OxyChem®

Wichita Plant

February 13, 2015

**RE: NOTIFICATION OF PLANT CHANGES; OCCIDENTAL CHEMICALS CORPORATION,
WICHITA PLANT; USEPA ID# KSD007482029**

figure 4

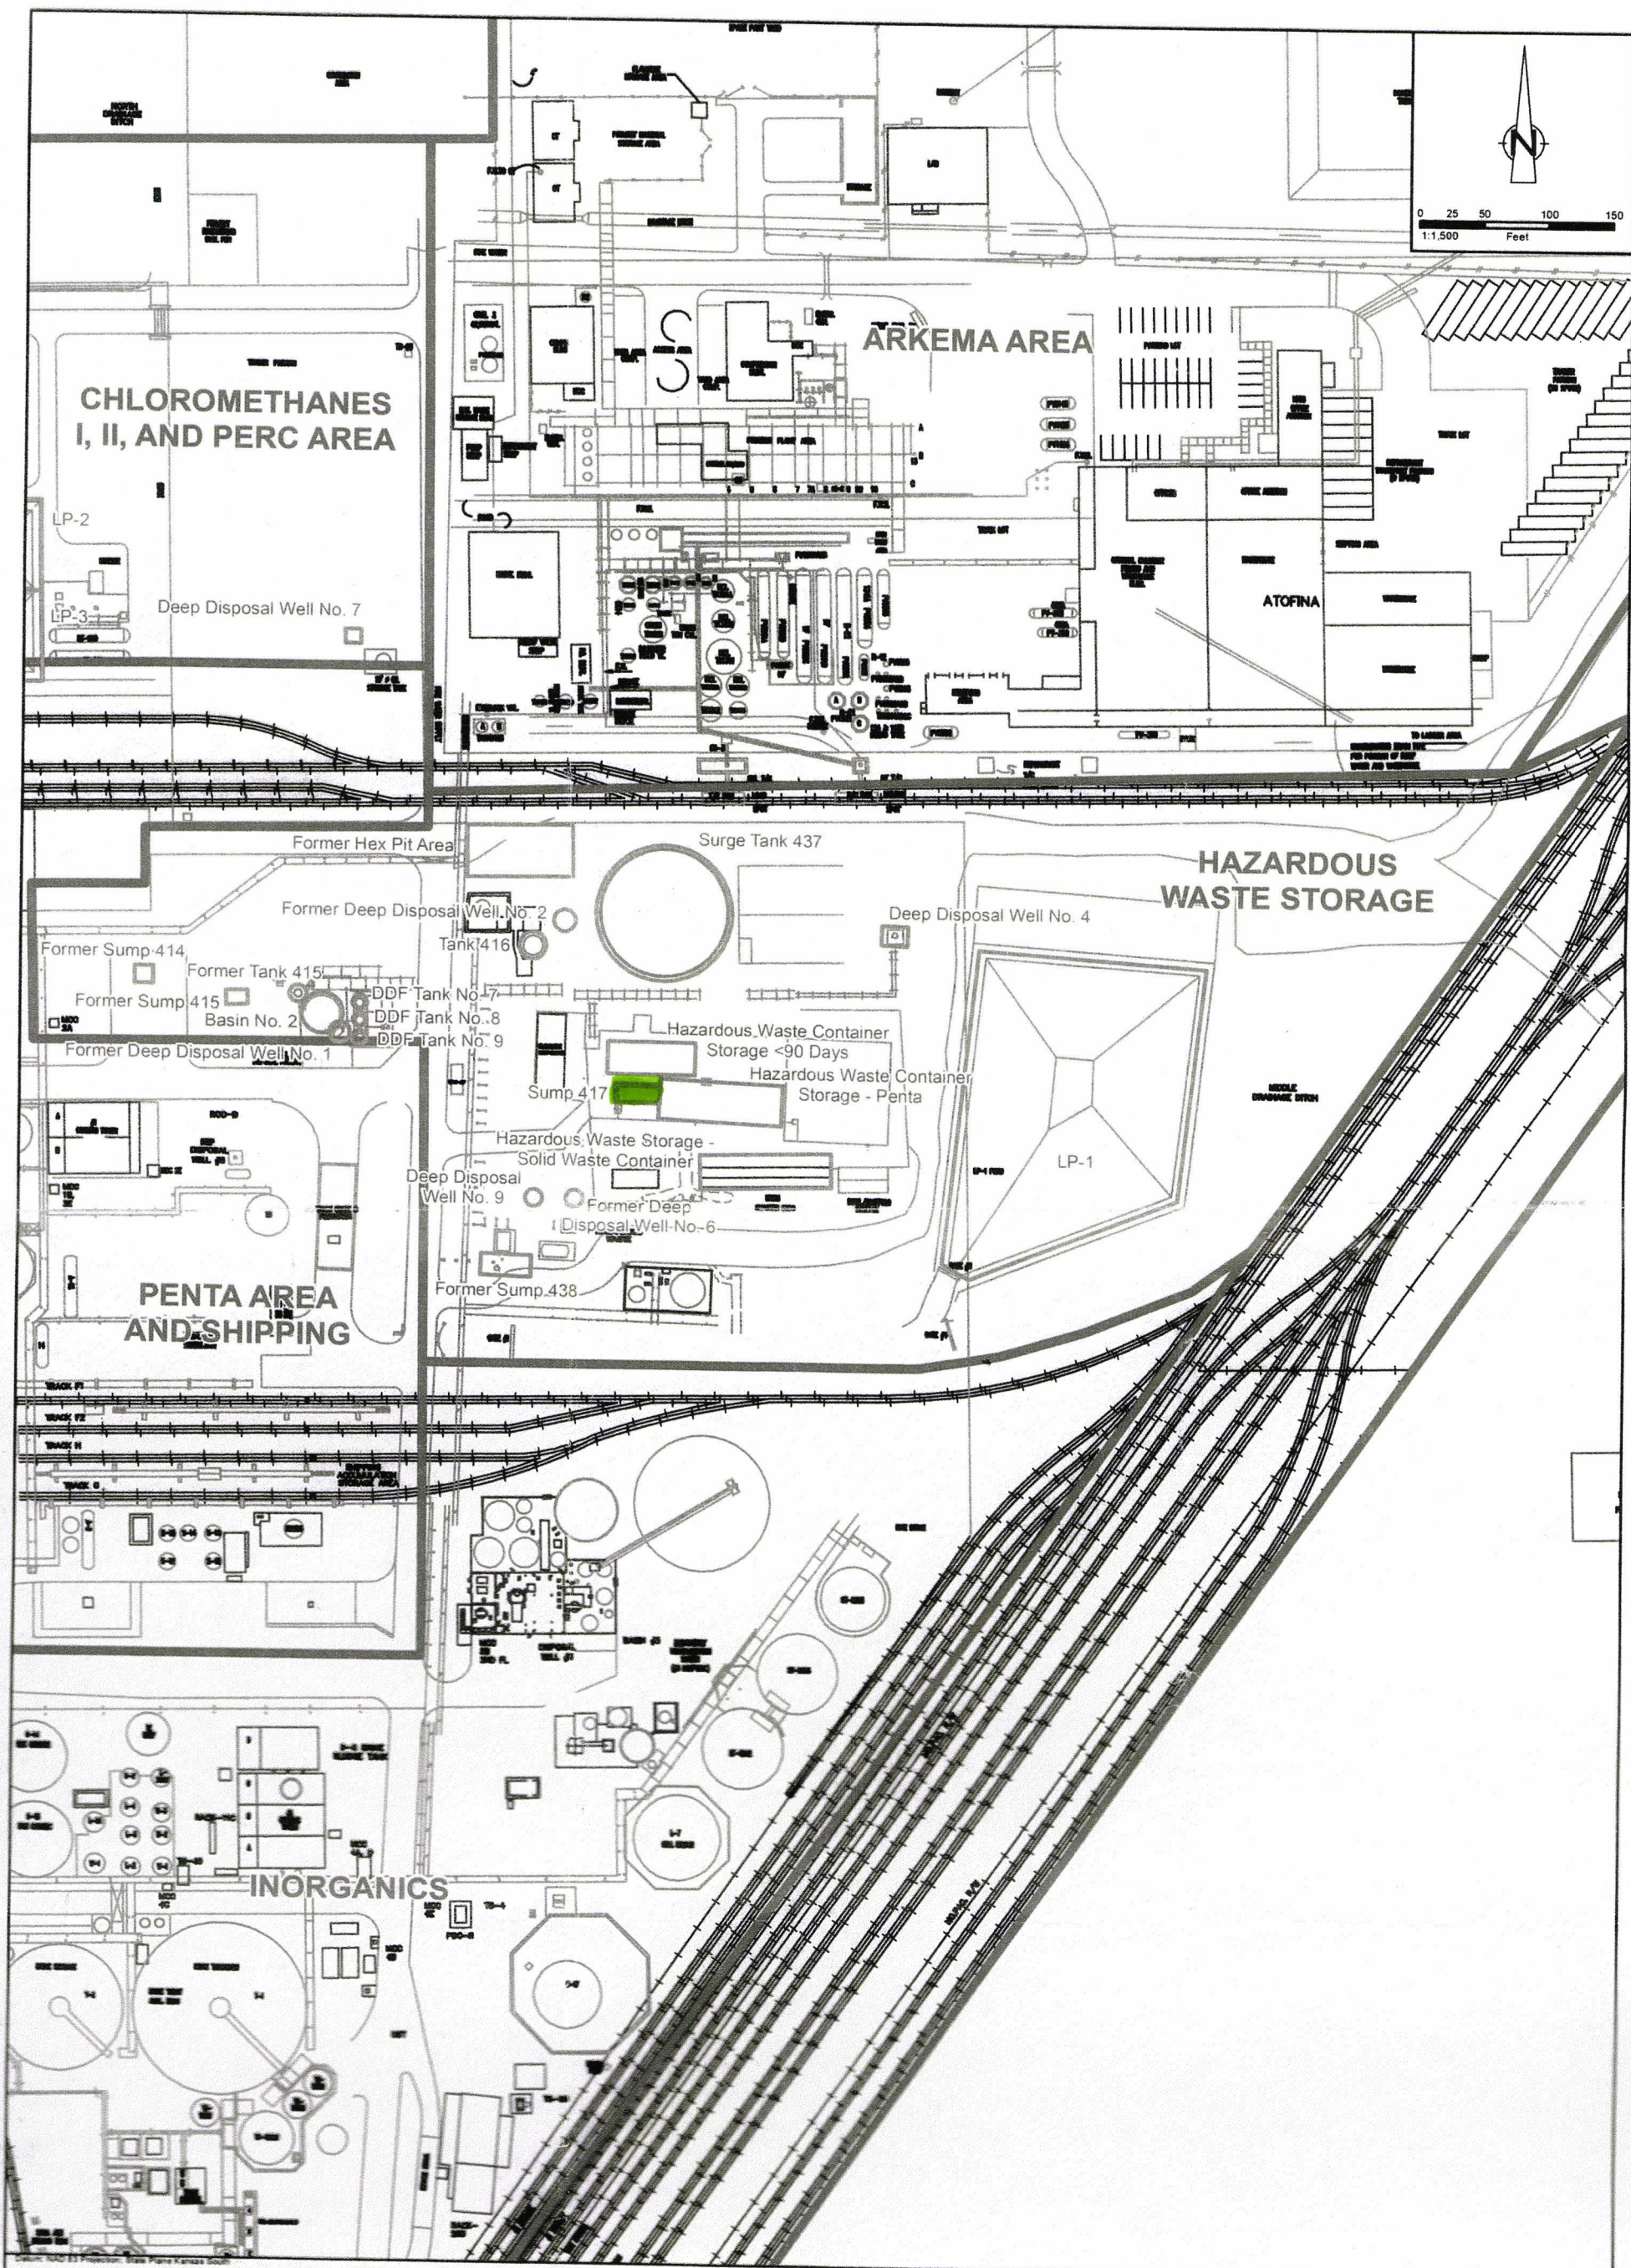
Enclosed please find a notification of a plant change, as required by Occidental Chemical Corporation's RCRA hazardous waste permit number KSD007482029 per *Section 1, I.E.10. Reporting Planned Changes*. The Wichita plant is planning on completing repairs and reducing the overall volume of Sump 417 located near the Pentachlorophenol Hazardous Waste Storage Yard. This sump is used for containment of the permitted Hazardous Waste Storage Yard, Pentachlorophenol Hazardous Waste Storage Yard which hasn't been utilized since 2005 when the Pentachlorophenol plant was permanently shut down, and the <90 day Hazardous Waste Storage Yard.

The repairs will be completed as weather permits. Additional concrete is going to be poured which will reduce the depth by approximately 14 inches and width by 8 inches. The proposed repairs and location map are attached for your review.
